**TOWN OF MOUNTAIN VILLAGE
REGULAR DESIGN REVIEW BOARD MEETING
THURSDAY MARCH 1, 2018 10:00 AM
2nd FLOOR CONFERENCE ROOM, MOUNTAIN VILLAGE TOWN HALL
455 MOUNTAIN VILLAGE BLVD, MOUNTAIN VILLAGE, COLORADO
REVISED AGENDA**

**SUMMARY OF MOTIONS
TOWN OF MOUNTAIN VILLAGE
DESIGN REVIEW BOARD MEETING
THURSDAY, FEBRUARY 1 2018**

TO: Design Review Board
FROM: Dave Bangert, Senior Planner
FOR: Meeting of February 1, 2018
DATE: February 22, 2018
RE: Initial Architectural and Site Review for a new single-family dwelling on Lot 201A, 106 Benchmark Drive.

LANDSCAPE PLAN

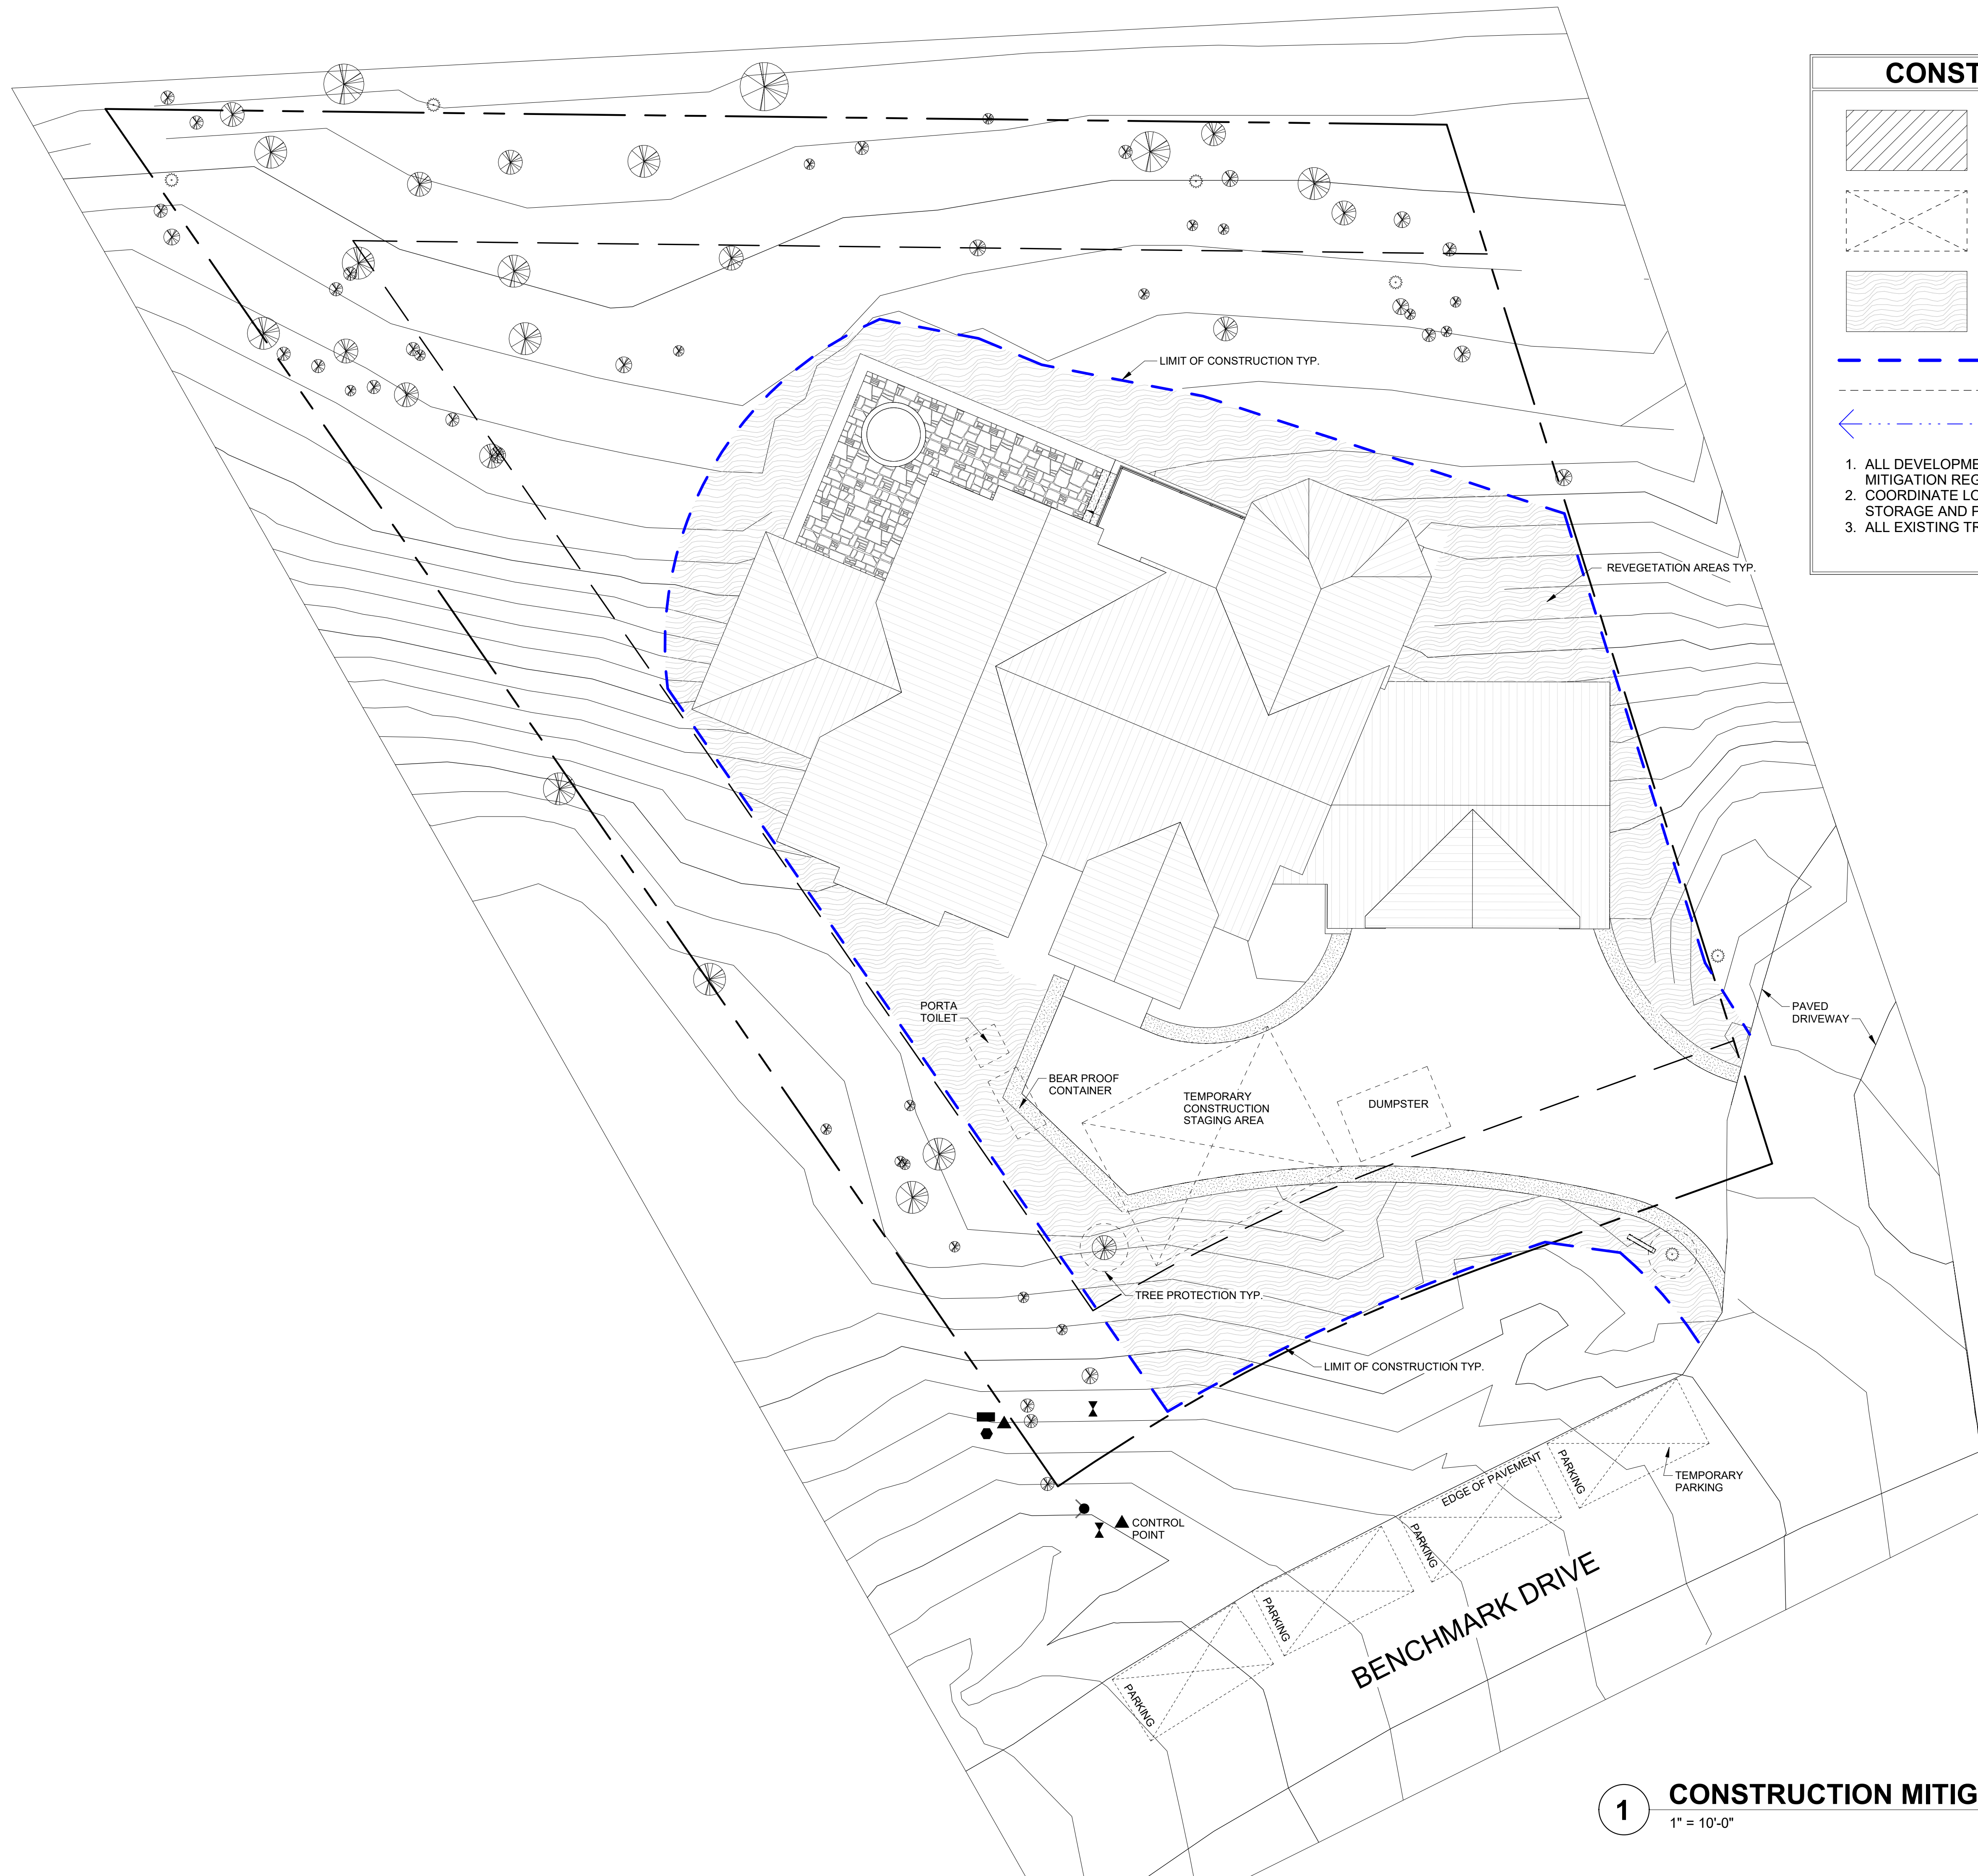
The proposed landscape plan shows 3 aspens, 4 spruces, 6 shrubs and 2 perennial beds with all disturbed areas to be re-seeded per CDC guidelines. All plantings will need to be in compliance with Table 5-4 of the CDC:

ROOF PLAN

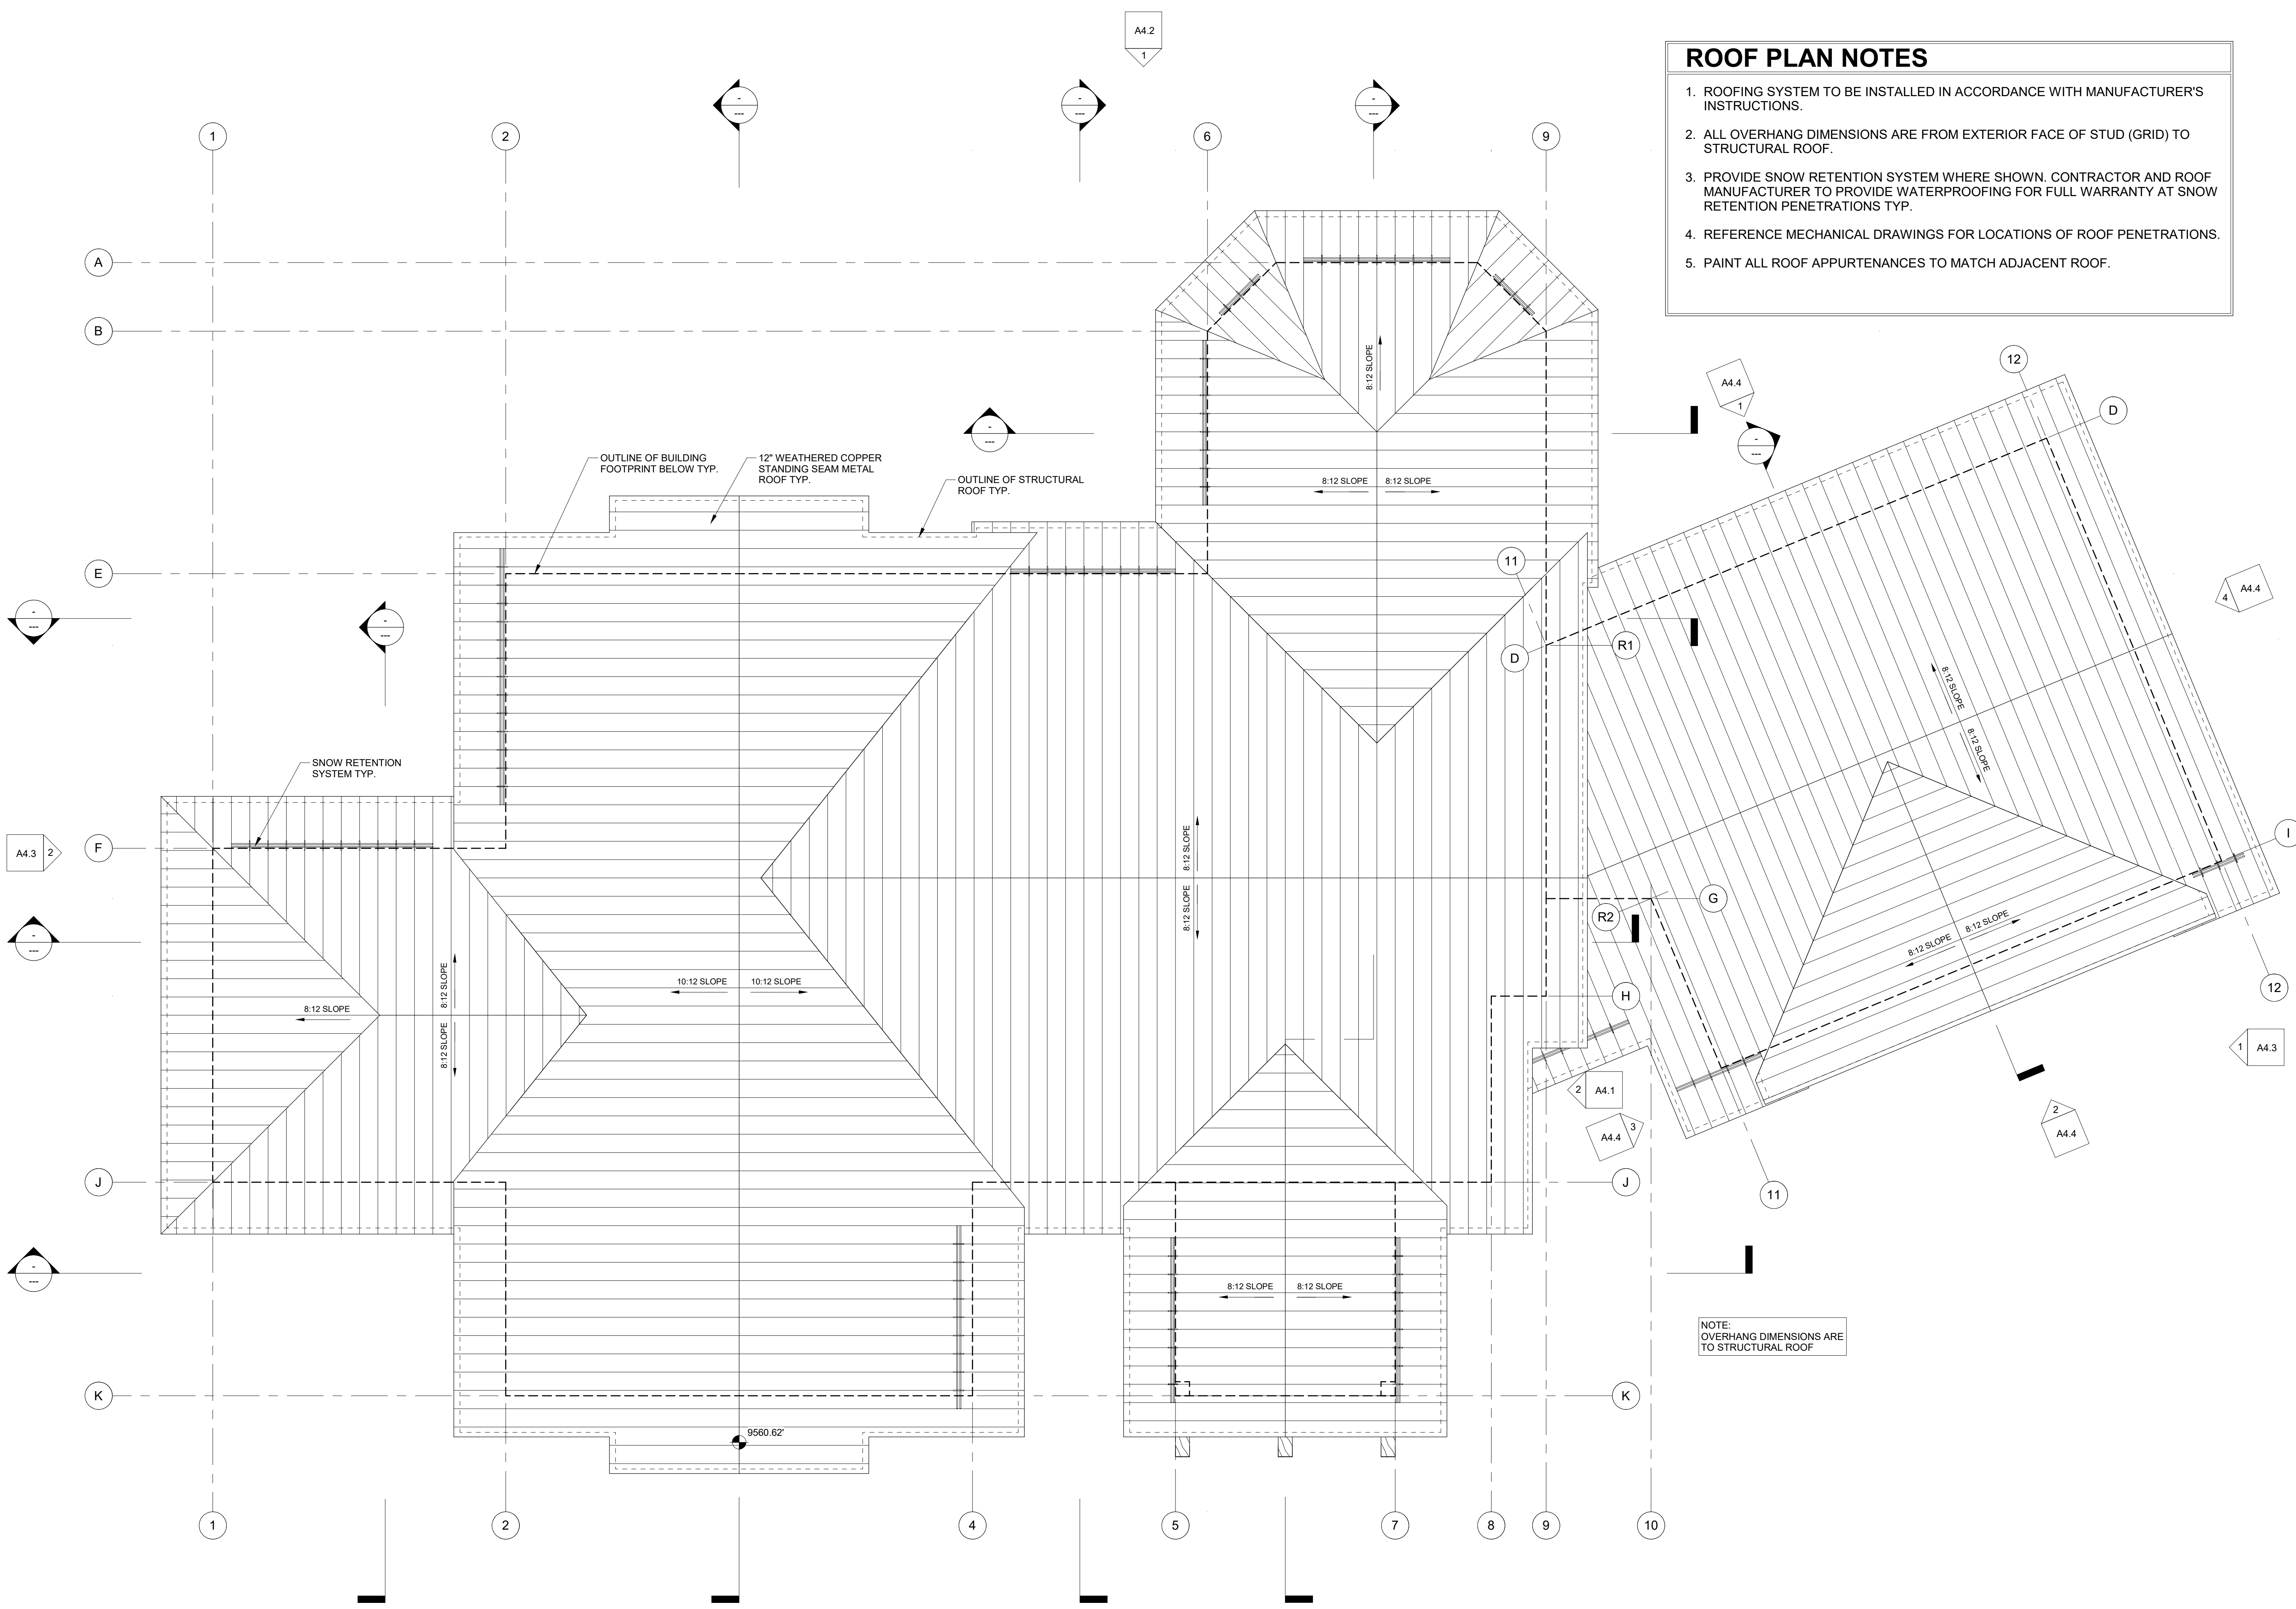
The CDC states that the roof shall be a composition of multiple forms that emphasize sloped planes, varied ridgelines and vertical offsets. The primary roof form for the residence is a 10:12 gable. The secondary roof forms are 8:12 gables and hips. The proposed roofing material will be weathered copper standing seam that will require specific approval from the DRB.
